CENPD-283-NP-A

Boiling Water Reactor Emergency Core Cooling System Evaluation Model:

Code Sensitivity for SVEA-96 Fuel

SAFETY EVALUATION BY THE OFFICE OF NUCLEAR REACTOR REGULATION
RELATING TO TOPICAL REPORT CENPD-283-P
"BOILING WATER REACTOR EMERGENCY CORE
COOLING SYSTEM EVALUATION MODEL:
CODE SENSITIVITY FOR SVEA-96 FUEL"

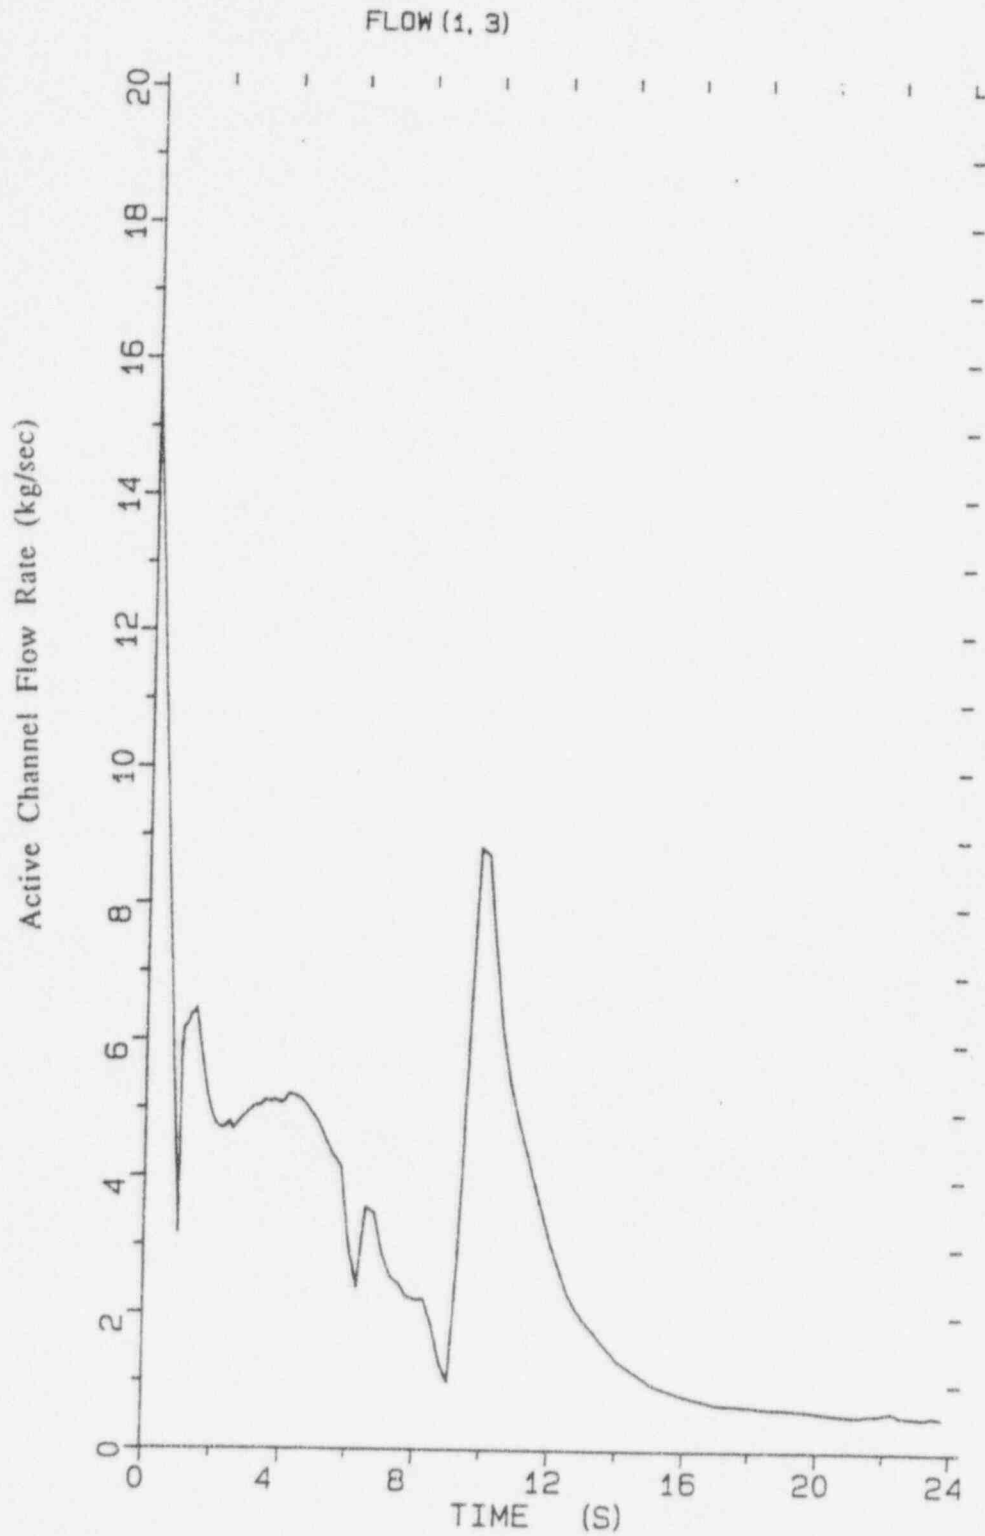
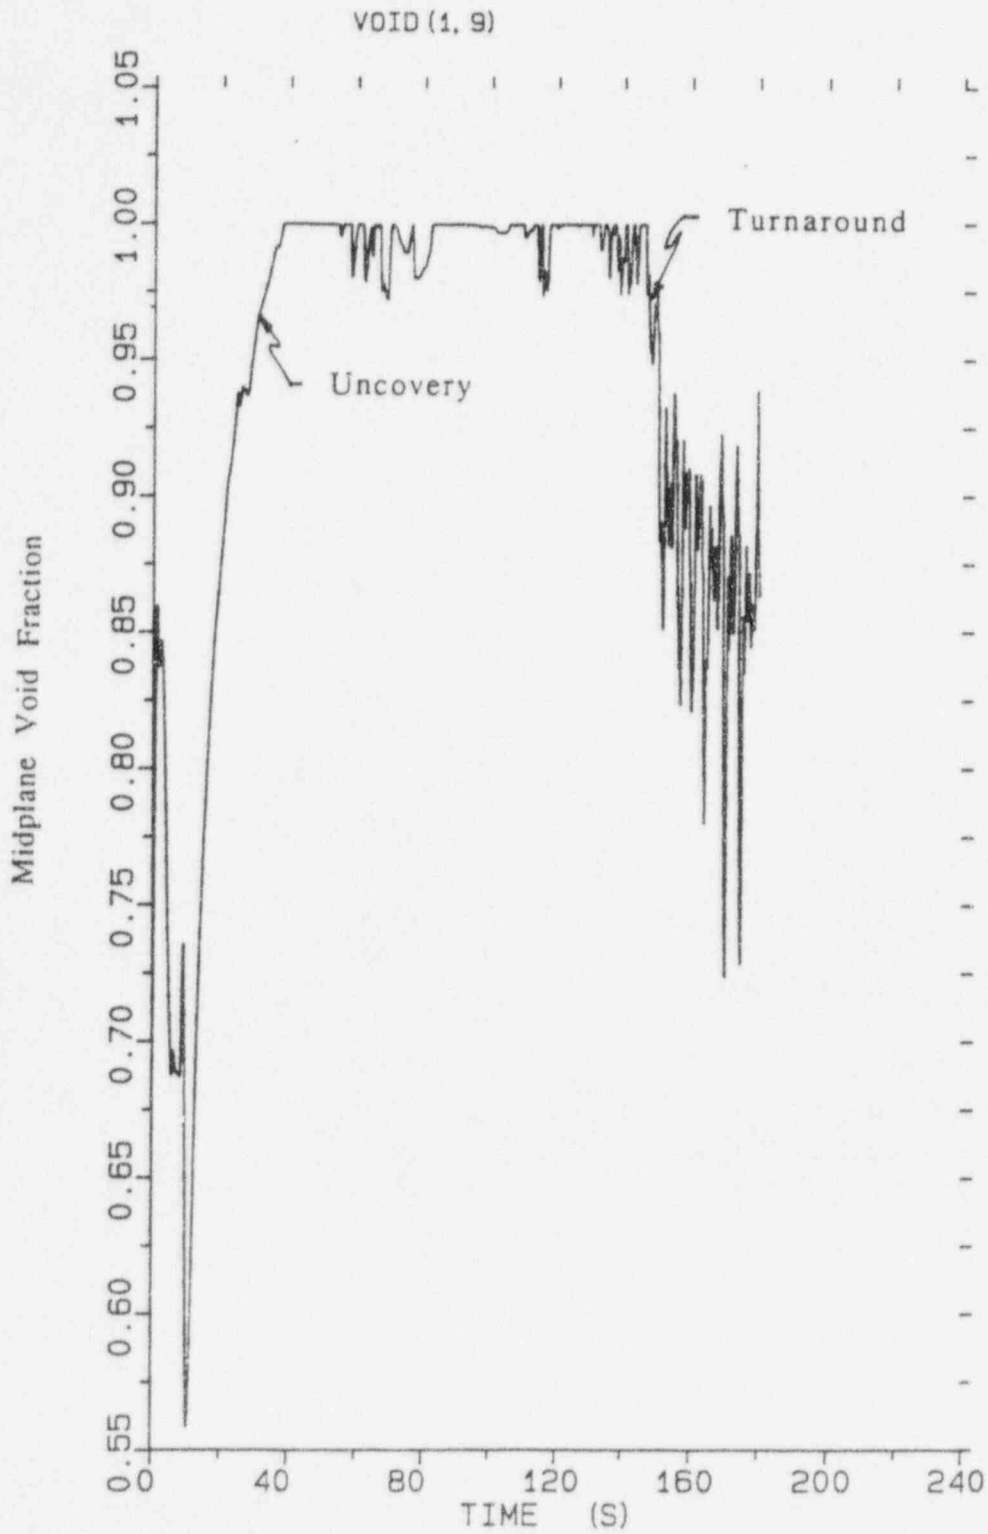
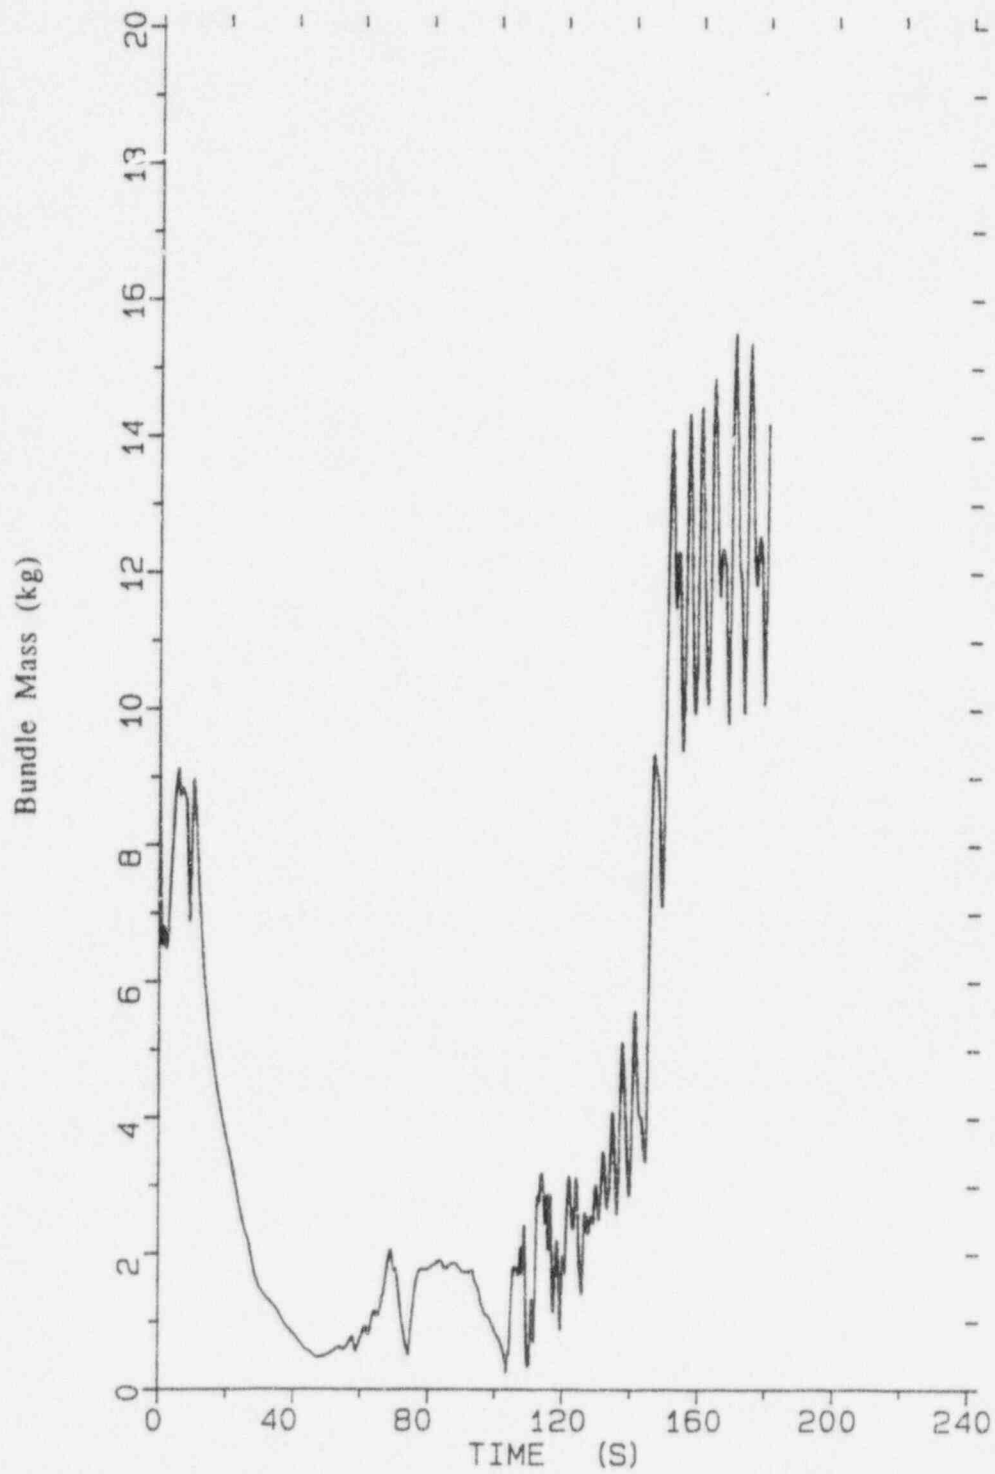
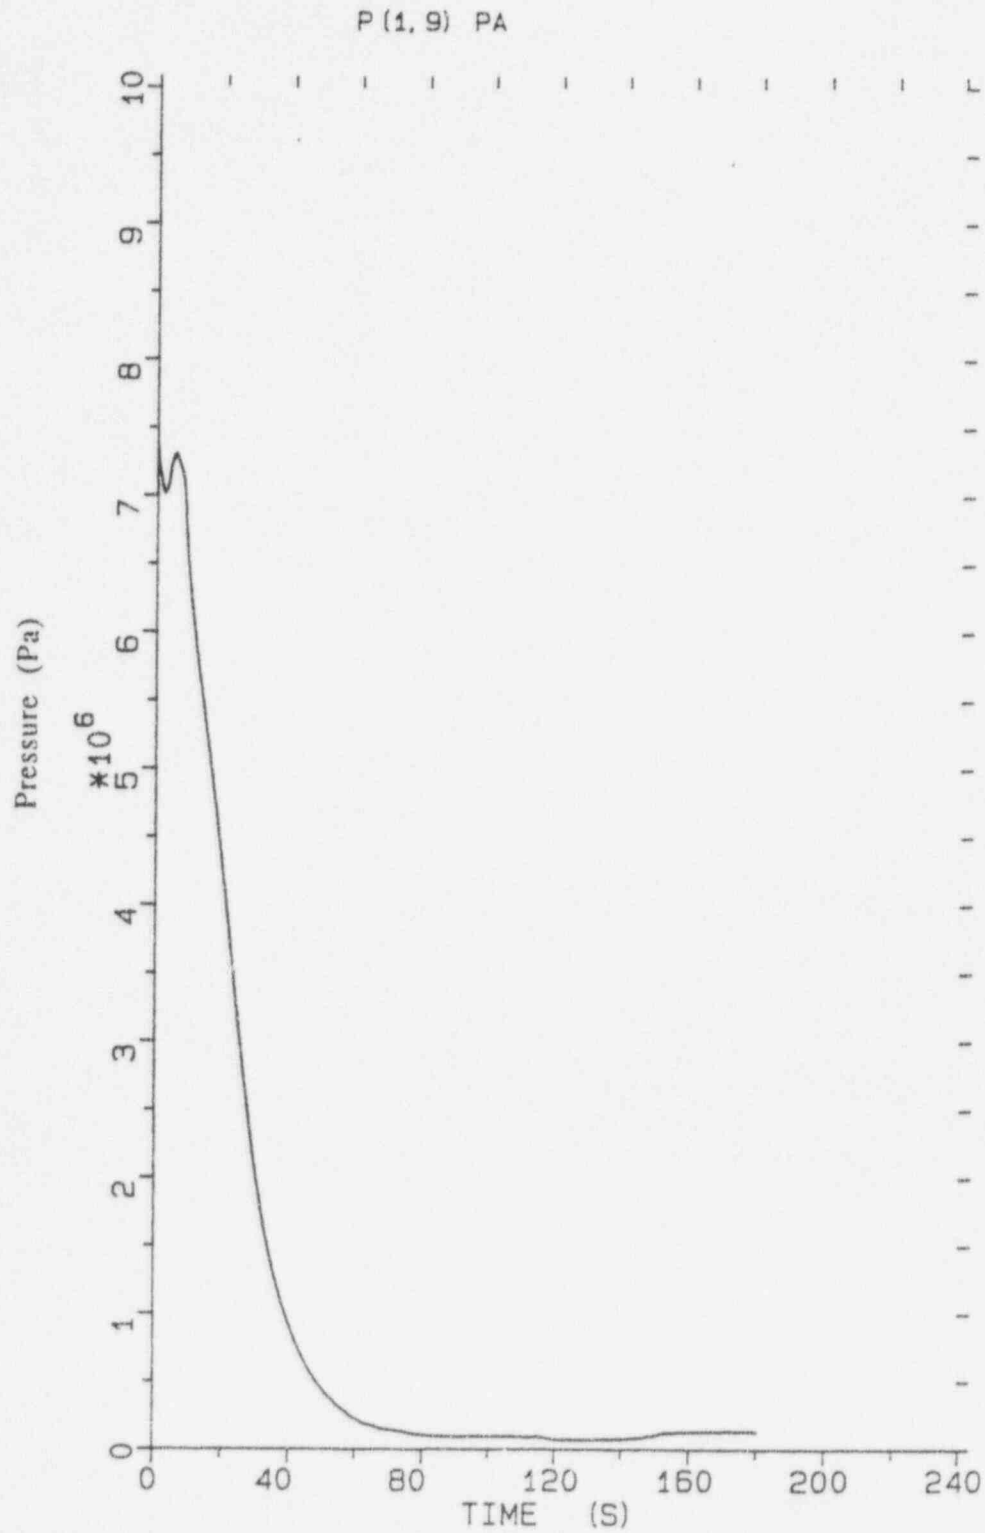
The vendor is relying upon conclusions reached with SVEA-64 to conclude that the same conclusion would be reached for SVEA-96 with the ECCS methodology. ABB/CE should provide FULL range of calculational graphic results and compare between analyses for SVEA-64 and SVEA-96 (p.15).

The full range of calculational results for the hot assembly response, discussed in Section 5.3, are shown for a sample case with SVEA-96 fuel in Figures 5.16 through 5.21 of this report. Similar calculational results were presented for the QUAD+/SVEA-64 fuel design in Figures 3.16 through 3.20 and Figure 3.22 of RPB-90-94-P-A (Reference A4). Figures A4-1 through A4-6 present a direct comparison of the hot assembly response for SVEA-96 and SVEA-64 fuel. This direct comparison shows the small differences between the two calculated hot channel responses. The small differences in results are attributed to differences in flow geometry, fuel rod geometry, nodalization, and simulation assumptions (all discussed in detail in this report). It is apparent that the differences in responses as a result of the change in fuel design and modeling assumptions are minimal.
